CITY OF ALBUQUERQUE

Re: Drainage Control Ordinance (14-5-2-1) and NPDES CGP Violations for Erosion and Sediment Control- Fairfield Suites

Drainage leaving site.

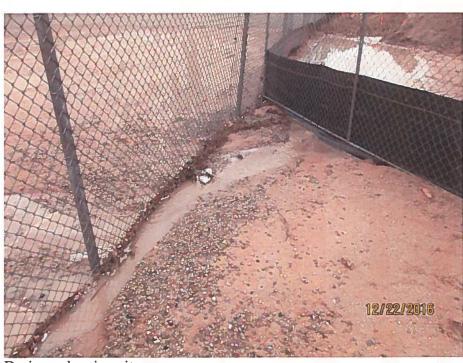
- 1. Drainage was observed leaving your site and entering the PNM substation. The photos were taken at 12:00 PM and it was still raining.
- 2. Numerous instances of cement pollution were observed and an acceptable concrete wash-out was not onsite.

- 1. Provide a temporary drainage solution that prevents drainage from entering the PNM substation.
- 2. Remove the cement pollution and provide an acceptable concrete/mortar/stucco wash-out receptacle.
